CITY OF ALLENTOWN

R140 – 2022

Certificates of Appropriateness for work in the Historic Districts:

- 811 W. Gordon St.
- 948 North St.
- 402 N. 6th St.

Existing condition of rear ell facing Refwal Street. (Applicant)

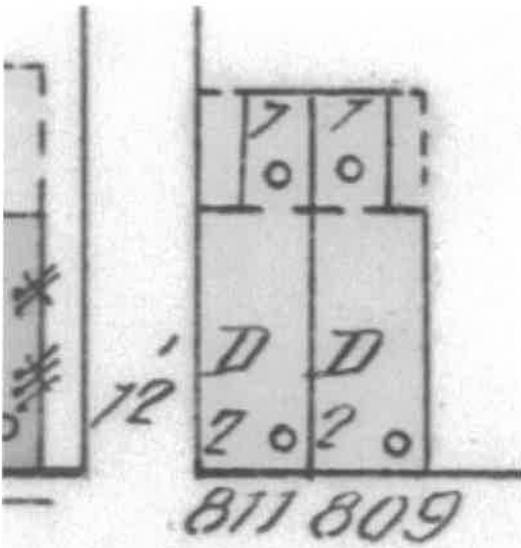
This application proposes to demolish and reconstruct the one-story rear ell. The applicant contends that the existing condition of the rear ell is beyond repair and requires reconstruction. The photograph provided by the applicant showing the existing conditions appears to illustrate that the ell has already been partially reconstructed with a new slab foundation, rafters, and plywood covering the walls. The floor plan indicates that one door will be installed in the rear wall with no other openings proposed. One boarded opening is shown in the photograph on the Refwal Street elevation. The staff questions whether the two other openings on the Refwal Street façade will be reconstructed.

The staff has requested additional information to determine whether the reconstruction of the ell is appropriate. Specifically, staff has requested elevation drawings or annotated photos with all exterior dimensions to show the proposed appearance of the ell; details and measurements of each building feature; a list of materials/features to be salvaged and reinstalled; and details on proposed windows, doors, and any new materials. Staff requested photos to illustrate the conditions and the necessity for reconstruction. The photos submitted appear to show a new condition rather than the deteriorated condition of the ell.

With sufficient evidence, the staff may find that reconstruction is appropriate. If more documentation is provided and it is found that reconstruction is necessary, the staff recommends that the reconstructed ell replicates the building's original appearance and complies with the previously approved work related to the door relocation and installation of new siding matching the original wood in dimension and style. The staff recommends that the applicant follows the original approvals (as detailed above) in replicating the historic windows, doors, and siding and that the dimensions, profiles, materials, locations, and proportions of all historic features are maintained.

HARB member Glenn Lichtenwalner made a motion to approve the application presented on 09/12/2022 for the reconstruction of the rear ell at 811 W. Gordon Street as submitted with vinyl windows based on prior COA approval for the main volume, establishing a precedent for approval and finds that the application is in compliance with the following sections of the Guidelines for Historic Districts: Chapter 3, Section 3.2 Wood Siding & Trim, Section 3.5 Windows, Section 3.15 Demolition, and finds that the circumstances unique to the property are the addition is part of a larger whole. HARB member Phillip Hart seconded the motion, which passed unanimously.

Rear garage of 948 North Street. (Applicant)

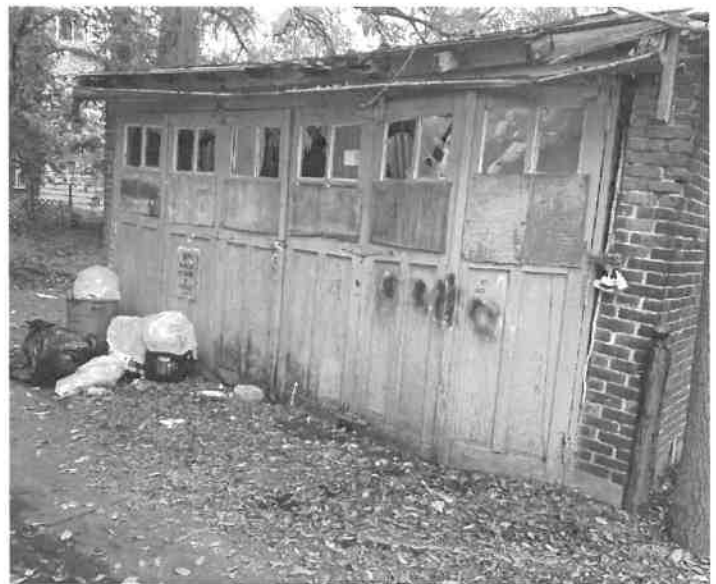
This application proposes to demolish the one-story brick garage of 948 North Street. The garage is located at the rear of the property, at the intersection of Palm and Brush Streets, with frontage on Palm Street. The roof collapsed at some point in the past, leaving the garage susceptible to the elements and causing further deterioration. On August 22, 2022, a city inspector from the Department of Building Standards and Safety designated the garage as an unsafe structure and ordered that it be razed or repaired within 30 days to abate a public safety concern. Owing to the extent of the damage, the owner is seeking to demolish rather than repair the structure.

The staff finds that the garage may have once contributed to the historic district but that the structure has lost its integrity from the damage and deterioration caused by the roof collapse. The building's compromised structural integrity has been documented by the Department of Building Standards and Safety as a public safety concern. The staff finds that the demolition is necessary to abate a dangerous condition and that the demolition will not have a negative impact on the district, because the garage is not visible from a primary street.

HARB member Phillip Hart made a motion to approve the application presented on *09/12/2022* for the demolition of the rear garage at *948 North Street* as submitted and finds that the application is in compliance with the following sections of the Guidelines for Historic Districts: Chapter 3, Section 3.15 Demolition, and finds that there are no circumstances unique to the property. HARB member Glenn Lichtenwalner seconded the motion, which passed unanimously.

Interior of the garage at 948 North Street. (Applicant)

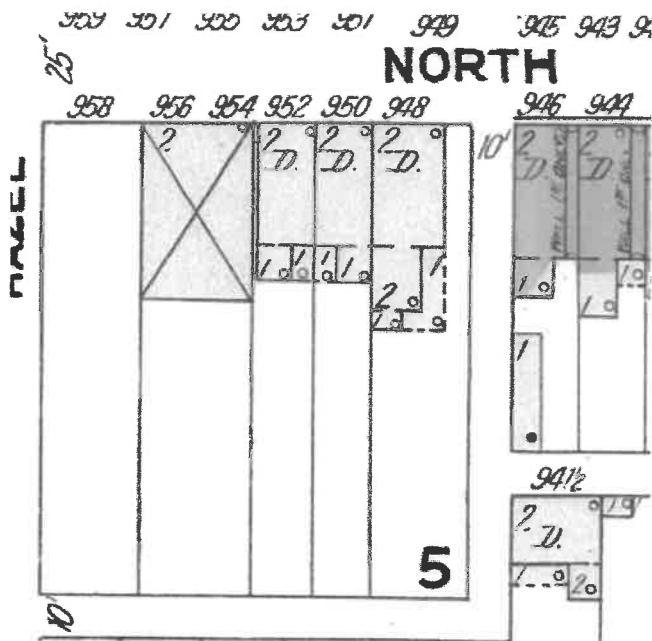
If the wood garage doors can be salvaged despite their severely deteriorated condition, salvage is recommended for potential repair and reuse at another building. If remaining wood window frames and/or sashes can be salvaged, this is also recommended.

1932 Sanborn Map showing that the garage at 948 North Street was constructed between 1911 and 1932. (PSU)

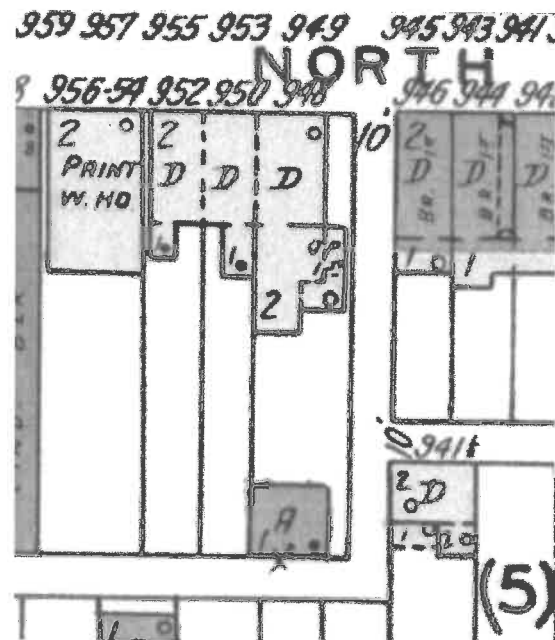
The garage was constructed between 1911 and 1932, several decades after the main building and does not reflect the same architectural character or materials as the house. The garage is located at the intersection of two service alleys and is minimally visible from North Street. Palm and Brush Streets consist largely of rears of buildings with several non-contributing, one-story garages. One residential building is located across the intersection.
